RE: **Lot 15 Block 6 Volcano Cliffs Unit 18 SAD 228
6516 Kimmick Dr.. NW
Grading and Drainage Plan
Engineers Stamp Date 5/12/2020 (D10D003M15)**

Based upon the information provided in your submittal received 6/17/2020, this plan is approved for Grading Permit.

PROJECT NAME:		
SHEET TITLE:		
SUBMITTED FOR:	SHEET NUMBER:	
<div style="text-align: center;"> <h1>VOLCANO CLIFFS</h1> <h1>6516 KIMMICK DR NW</h1> <h1>PULTE ID 13</h1> <h2>GRADING AND DRAINAGE PLAN</h2> <h2>GRADING PERMIT</h2> </div>		
1 OF 1

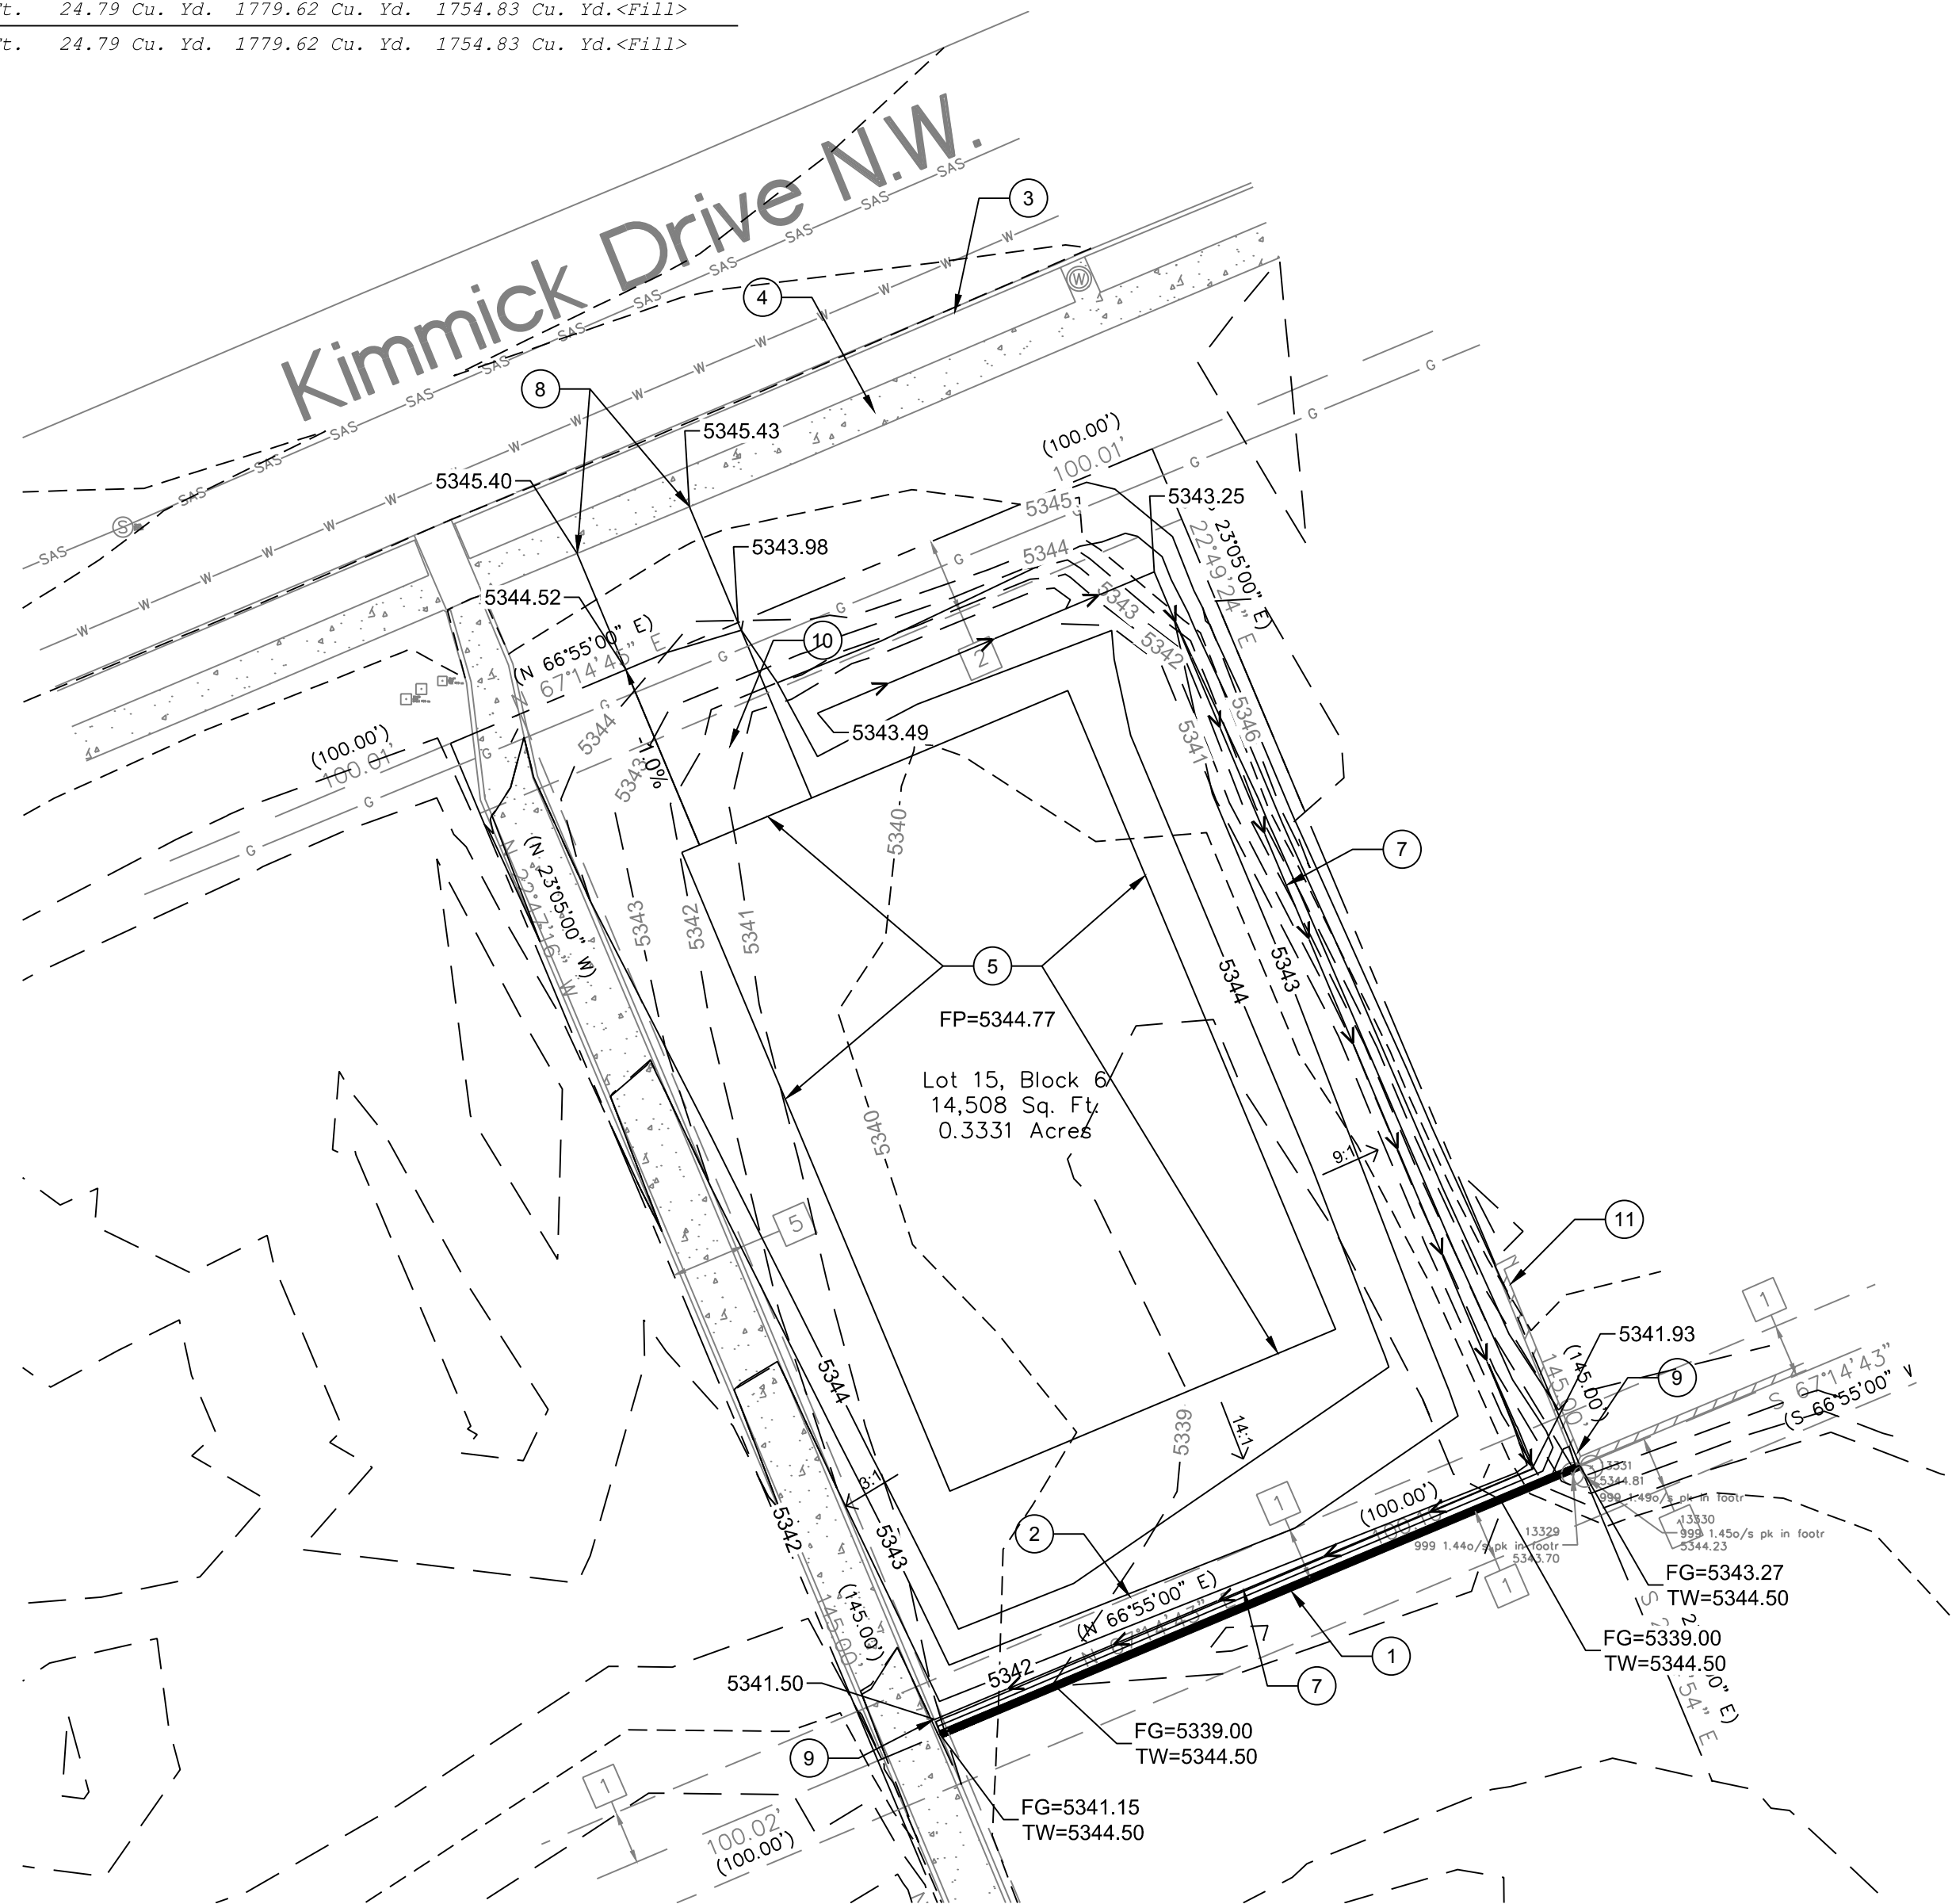
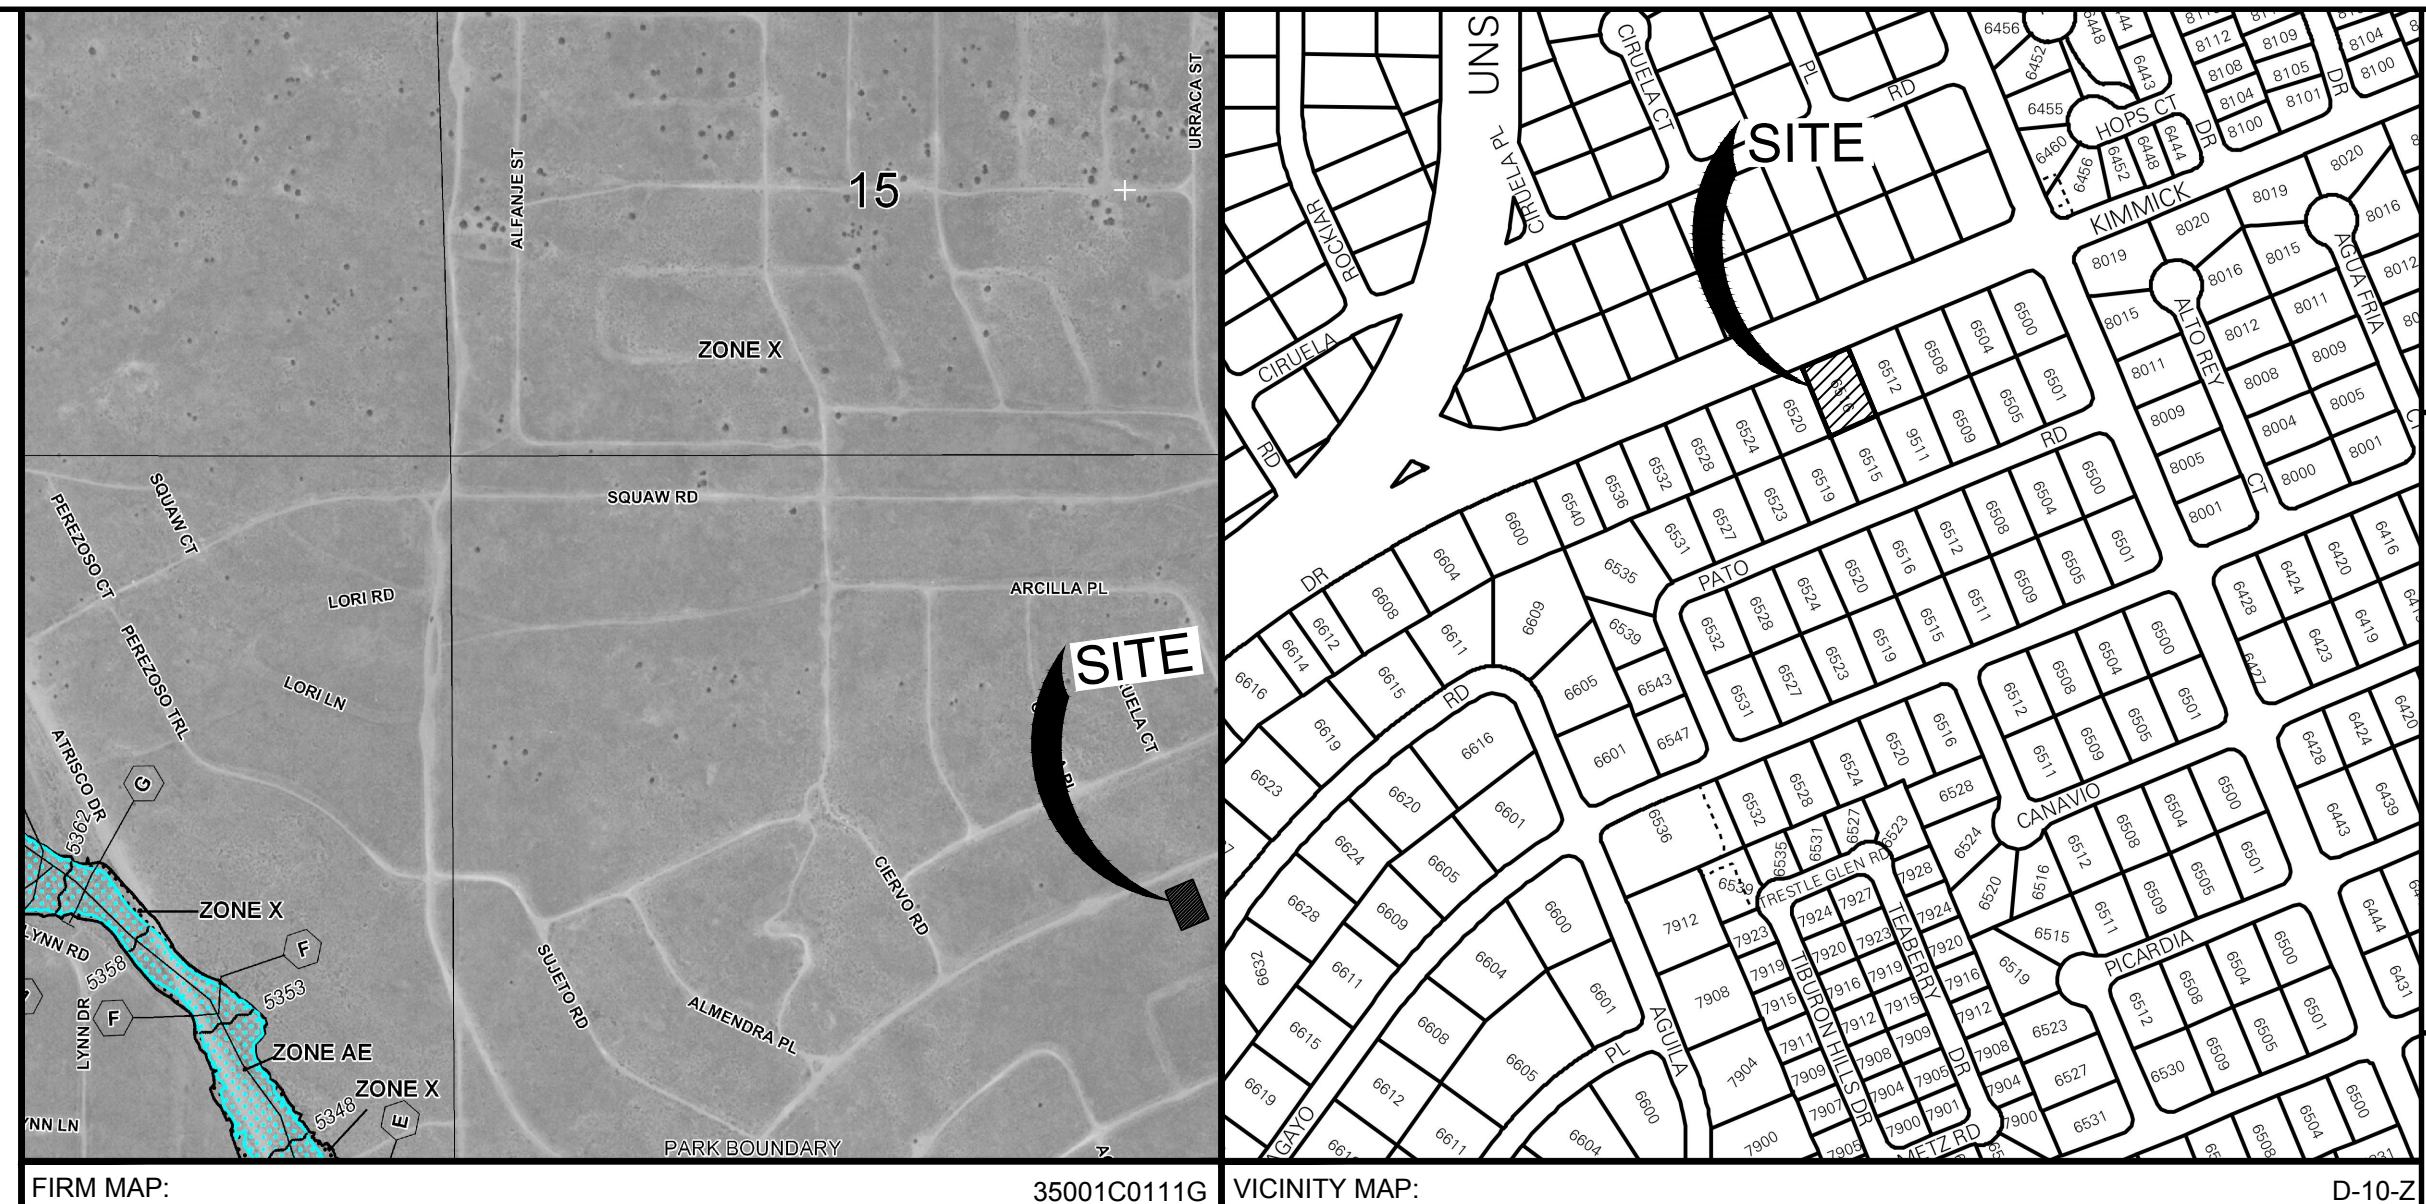
Reiterate to the Owner/Contractor that a separate permit for a garden/retaining wall must be obtained with the approved G&D plan and Pad Certification. **Also, if a swimming pool is to be placed the grading and drainage plan will change and will need to be resubmitted.**
